July 27, 2022

**MECA COMMENTS
ON THE
CALIFORNIA AIR RESOURCES BOARD'S
ADVANCED CLEAN CARS II REGULATION
PROPOSED 15-DAY CHANGES**

Figure. Proposed Canister Sizing to Control Puff Losses

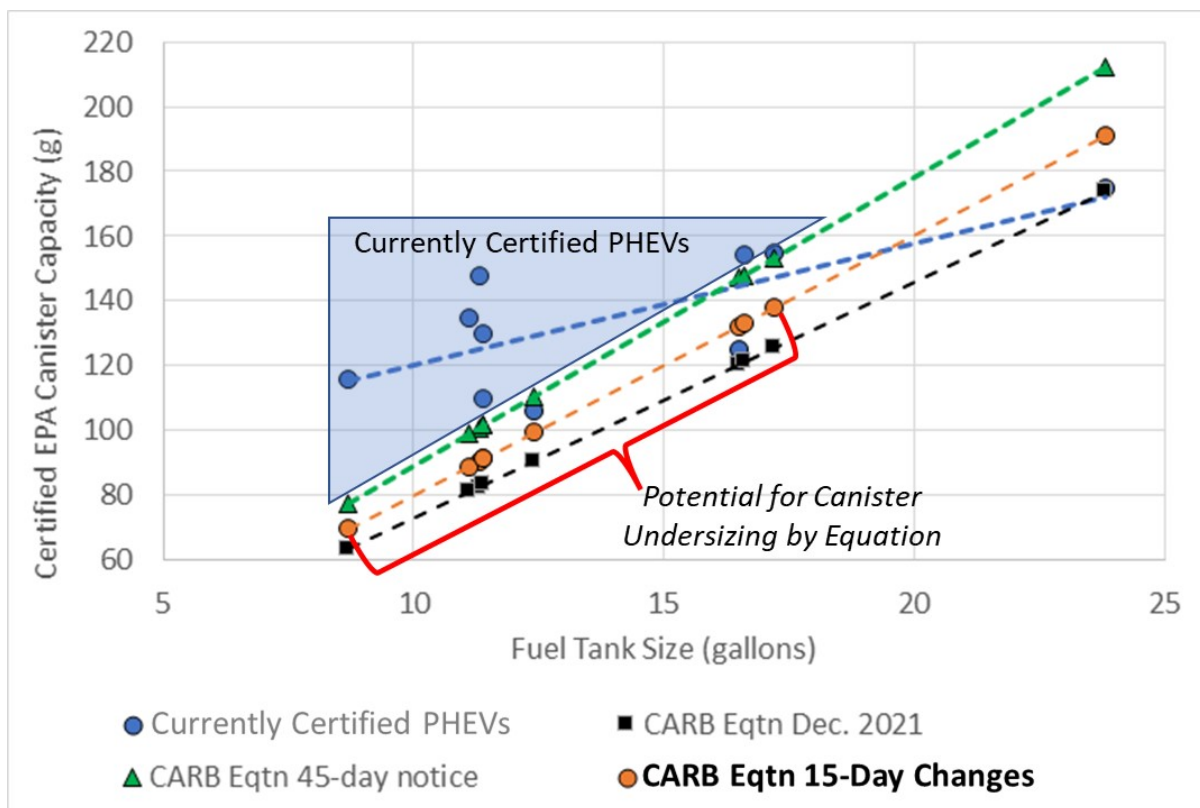
MECA has compared the latest proposed version of the equation in the figure above and compared it with previous equation versions and actual canister size values from certified vehicles (see our 45-day comments for details of the vehicles). As can be seen, the proposed reduction in the “carbon aging factor” from 1.2 to 1.08, represented by the orange line, lowers canister sizing below that of existing certified vehicles. Thus, rather than representing a suitable fit to today’s certified vehicles, it would represent an increased risk of undersizing evaporative canisters for vehicles with fuel tanks smaller than 15 gallons. Given that the majority of vehicles employ smaller sealed NIRCOS fuel tanks, we believe it is vital that the equation be further refined to more accurately represent the certification data of smaller NIRCOS fuel tank sizes. The previous carbon aging factor of 1.2 used in the equation proposed under the 45-day changes was based on data from BWC measurements, and therefore, we believe it provides a better fit to the data for smaller fuel tanks as shown by the green line in the figure.

We also believe that the proposed change in the evaporative aging factor warrants further review for the following two reasons;

- GWC is a parameter used in canister effectiveness assessments by suppliers and OEMs but it has no regulatory basis and is not referenced in any regulatory requirement or provision that MECA is aware of. GWC is not defined in current regulations and there is no established test procedure, whereas the concept of BWC is addressed by both ASTM test procedures and EPA/CARB regulations. The lack of an established correlation between GWC and BWC provides a further complication to the proposed change.

- the compliance with the “minimum canister nominal working capacity” requirement should be based on canister BWC as the other terms in the equation are based on BWC. There is an established requirement for canister nominal working capacity measurement based on canister BWC (see Part III.D.3.3.4) which has been part of the CARB/EPA evaporative emission regulations for decades. CARB first proposed an “aging factor” of 1.2 based on BWC data which was acquired from in-use canisters. Therefore, it is not technically appropriate to use GWC data for the aging factor in the above equation, but to then use BWC for compliance.
